**SERVICE BULLETIN**

**NUMBER:** 06-46-14

**SUBJECT:** Revised Brake Light Switch Adjustment Procedure for DTCs C1531 and C0054

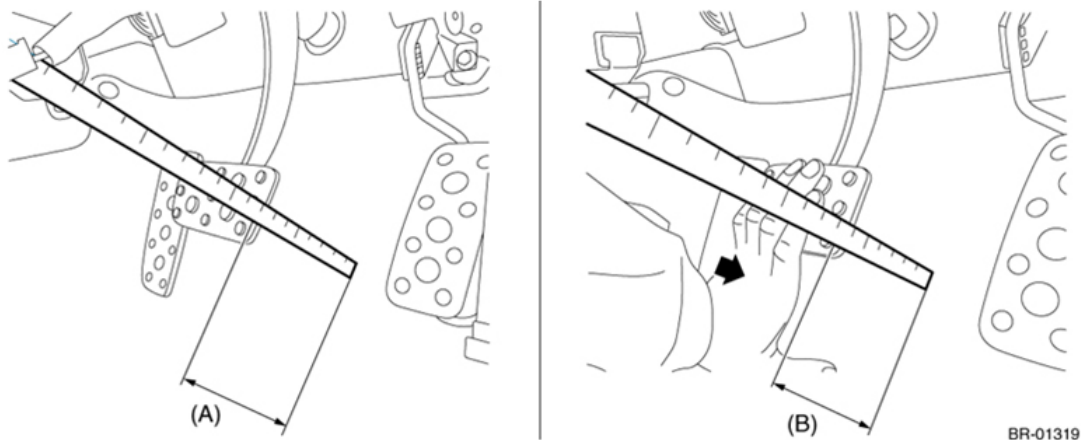
1. Before removing or adjusting the BLS, put a reference mark (a) on the threaded/notched portion as shown in the illustration below.

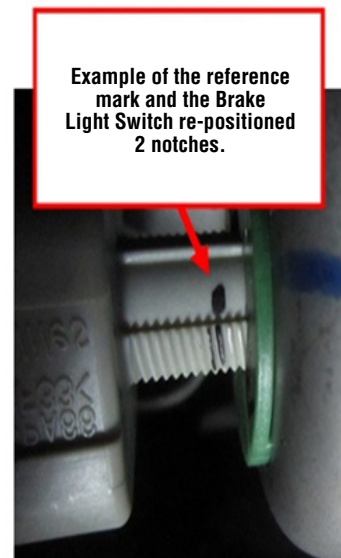
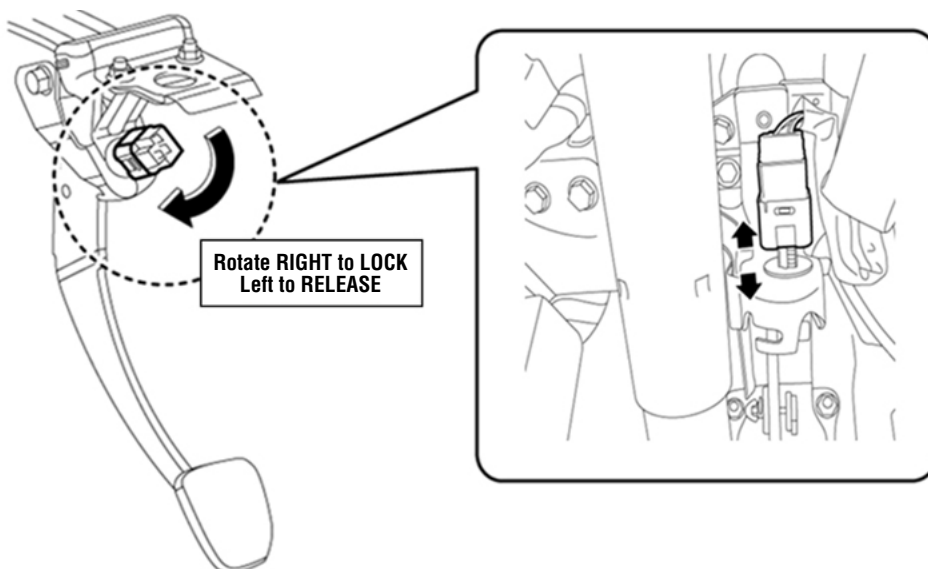
- As shown in the next illustrations, measure the brake pedal stroke by first measuring the distance “A” between the floor mat and the pedal. Depress the brake pedal slowly until the brake lights come on “B” then record the second measurement. Subtract “B” from “A” to obtain the pedal stroke measurement.

**The specification for pedal stroke to activate the BLS is 5.5mm +/- 2.5mm (>3mm but <8mm).**

- If the measurement (switch activation) is out of specification, the BLS will need to be adjusted. When the brake lights come on too soon (not enough pedal stroke), the BLS needs to be adjusted “inward” toward the bulkhead while if the pedal stroke is excessive before the brake lights come on, the BLS will need to be adjusted outward toward the steering wheel. The BLS adjustment is sensitive and in most cases, moving it just one notch should bring the operation into specification since one notch is equivalent to approximately 4mm of movement.

- If it is determined the BLS needs adjustment, rotate the switch approximately 45 degrees to the left (counter-clockwise) to release it from the pedal bracket. You will need to develop a “feel” for the adjustment notches along with how the BLS releases and locks back into place. Move the BLS inward or outward as required using your reference mark (see Step 1) as a guide then rotate the BLS to the right (clockwise) to lock it back into position. Re-measure the pedal stroke. If the switch operation is within the specified limits, the adjustment procedure is complete. If the switch operation is still out of range, repeat the adjustment procedure.
